ASME Code Case N-838 *Thoughts*

David Rudland
U.S. NRC RES/DE/CIB
June 5, 2014

NRC/EPRI Materials Issue Program
Technical Information Exchange
June 3-5, 2014

Toughness Comparison

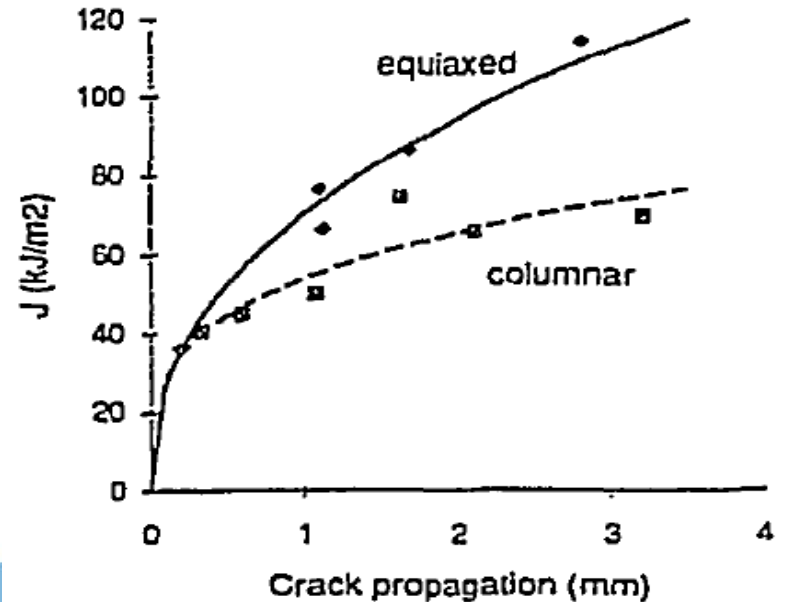
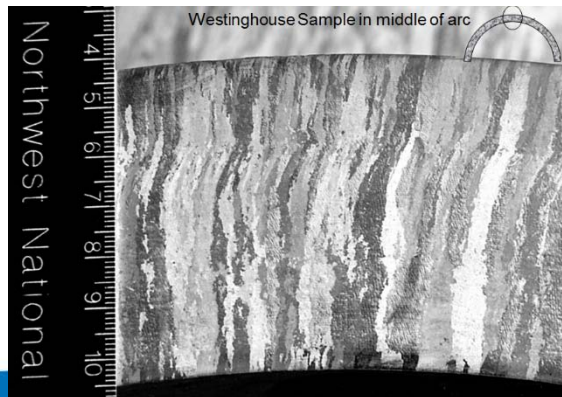
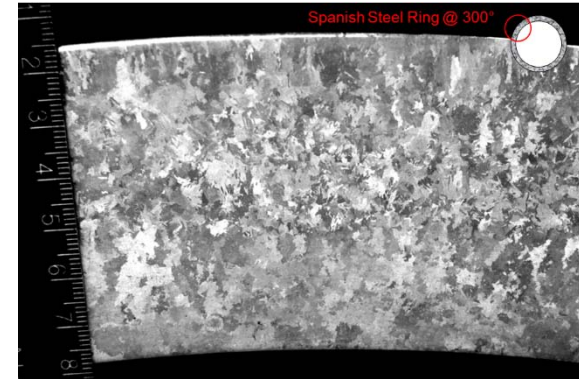
- NRC staff members (3) and contractors (2) voted negative at both the Working Group and Subgroup levels
- Negative votes were based on confidence issues in the best estimate models and selection of input parameter uncertainties
- Through discussions and sensitivity analyses, most issues were addressed
- Issue of proper fracture toughness distribution remains

- SIA developed aged CASS toughness distribution from data published by Argonne National Laboratory (ANL)
- Emc² (NRC contractor) located applicable data from leak-before-break (LBB) submittals and foreign operators that suggest much lower toughness than in ANL reports
- CASS toughness highly dependent on grain size and orientation

- Emc² plans:
 - Develop revised distributions of fracture toughness for fully aged CASS
 - Different cases where chemistry is available for CF8M
 - Develop realistic coefficient of variance
 - Establish how the strength changes with aging for the same materials
 - Possible to have concise cross-correlation of strength and toughness
- Conduct confirmatory probabilistic analyses
 - Use PROLOCA
- Continue discussions at Working Group level
